DOCUMENT 00 90 30
ADDENDUM No. 3

- A. The Construction Contract is known as:
SA009 – CIP – 12TH ST/CENTURY DR – PHASE 1
- B. Date of this Addendum: 2/13/2026

NO.	DESIGNED	DRAWN	CHECKED	SHEET NO.	PP1
84	AX	MB	CI	6 of 18

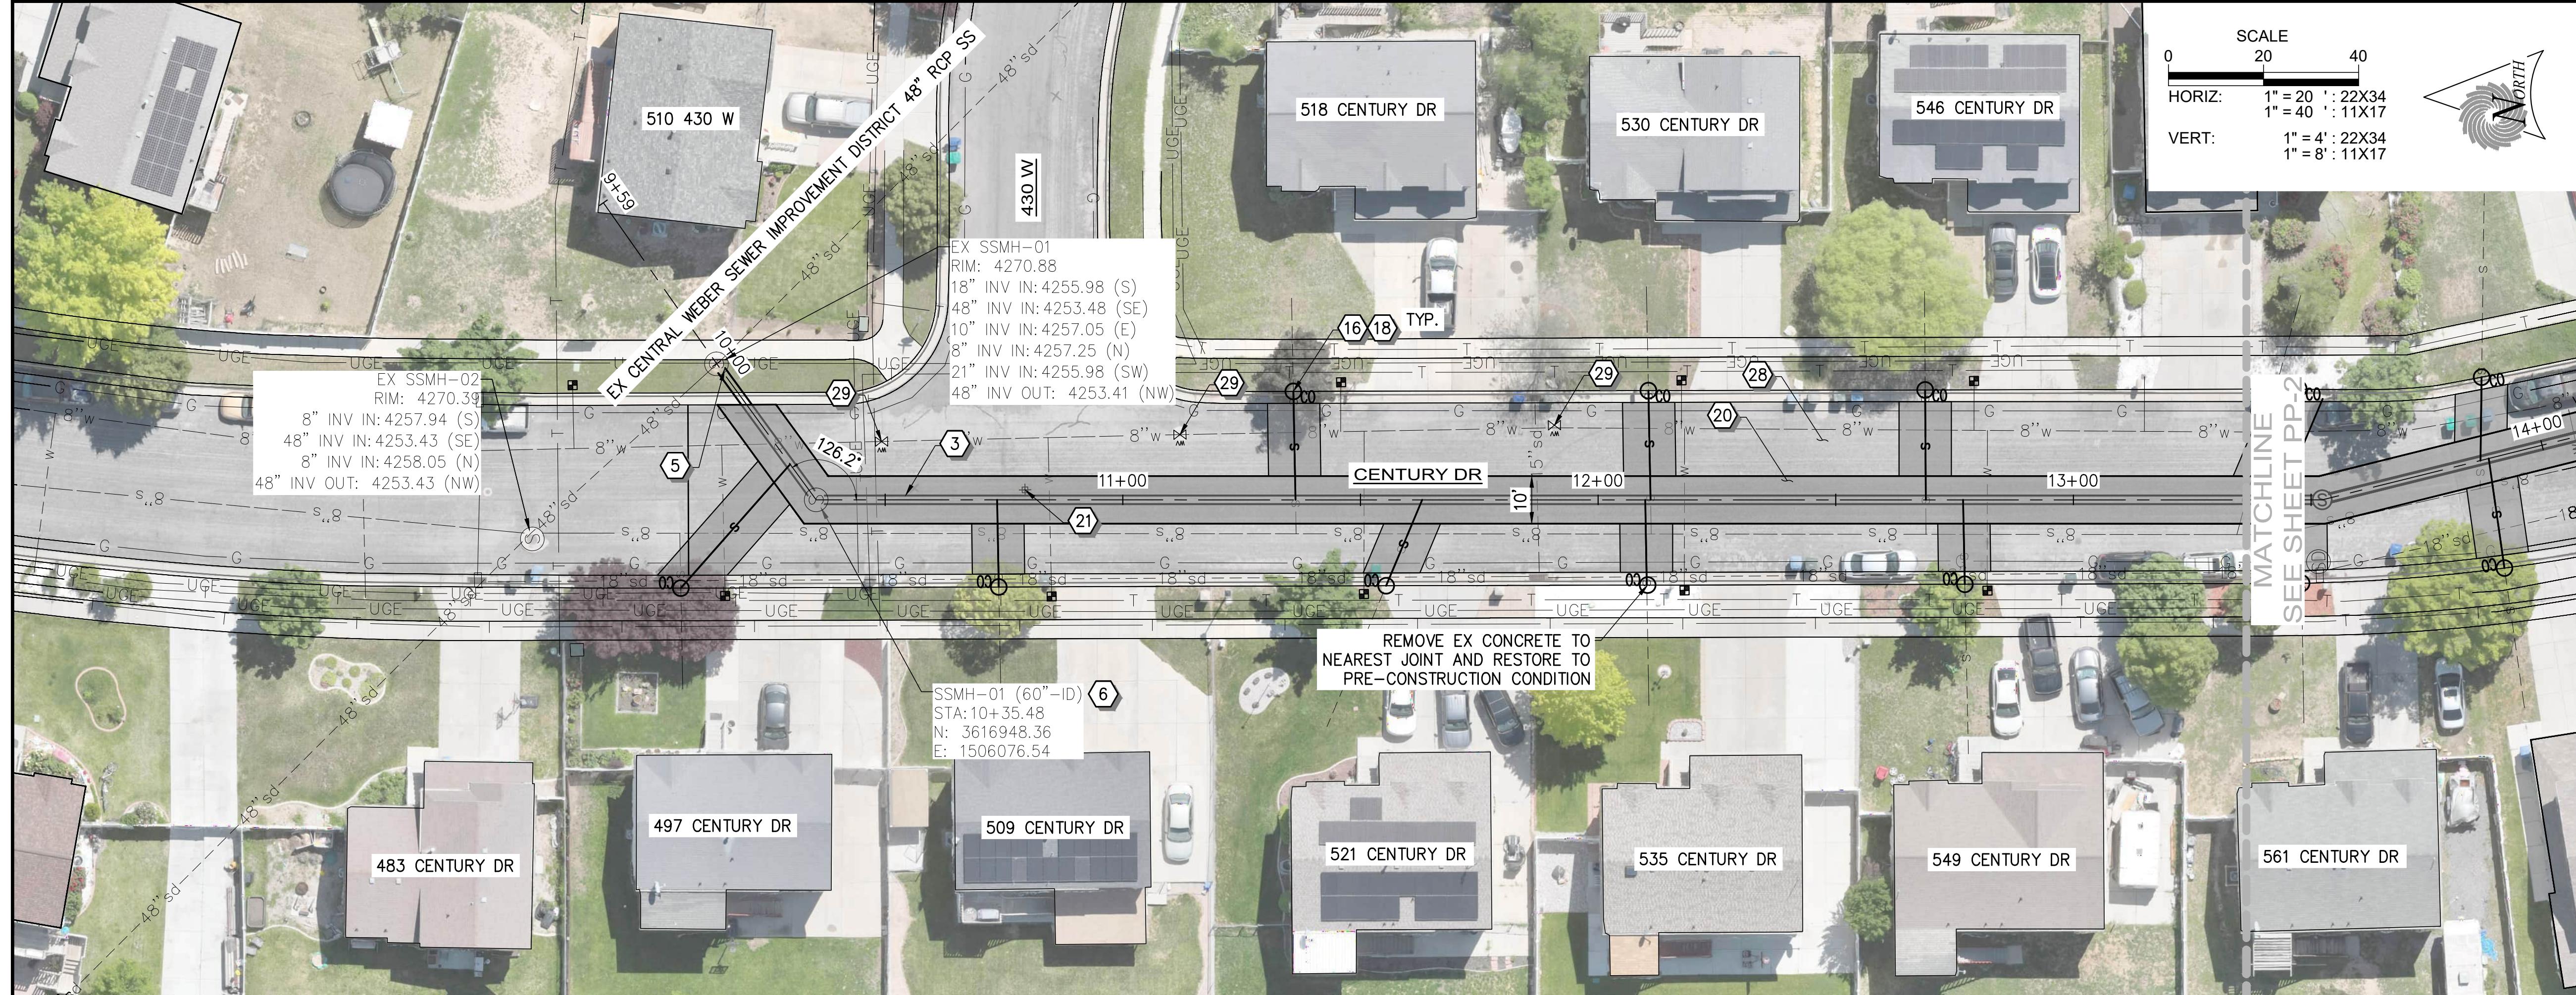
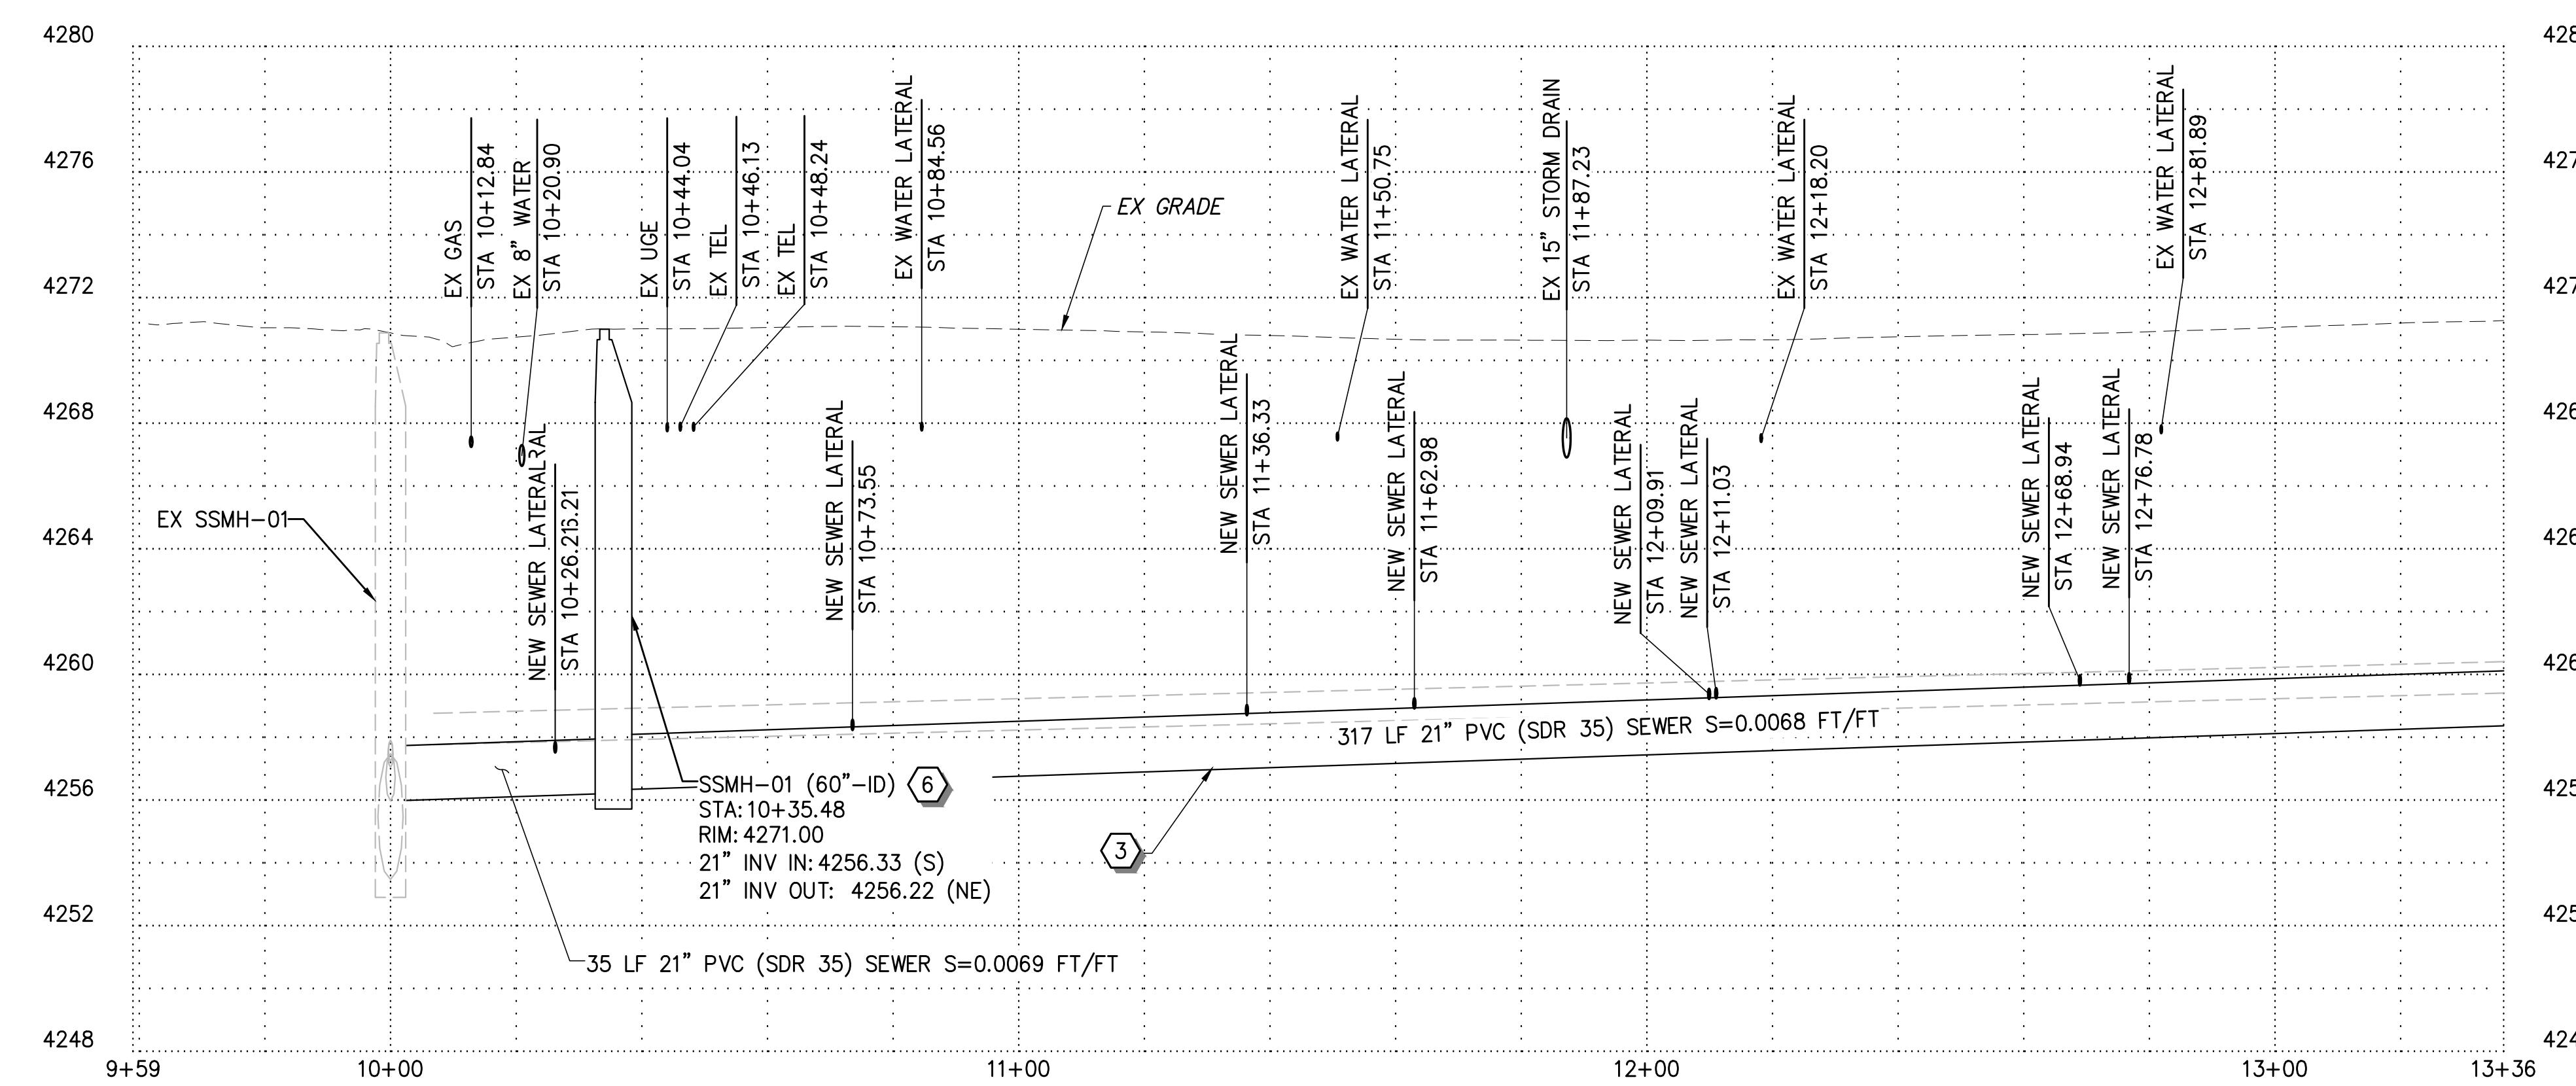
- A. Sheet PP-1 to PP-7 and C-1. Changed Construction Keynote 28 from "1" Mill and Overlay" to "2" Mill and Overlay"

23	R&R CURB & GUTTER	RD-4 D-1	
24	R&R SIDE WALK	RD-5 D-1	
25	R&R FENCE		
26	R&R UDOT PANELS	PV 2 D-5	PV 3 D-6
27	R&R UDOT CURB AND GUTTER	CW 2A D-8	PV 5 D-7
28	2" MILL AND OVERLAY		
29	RAISE AND COLLAR EX WATER VALVE		
30	RAISE AND COLLAR EX MANHOLE		
31	REMOVE EX WATER VALVE
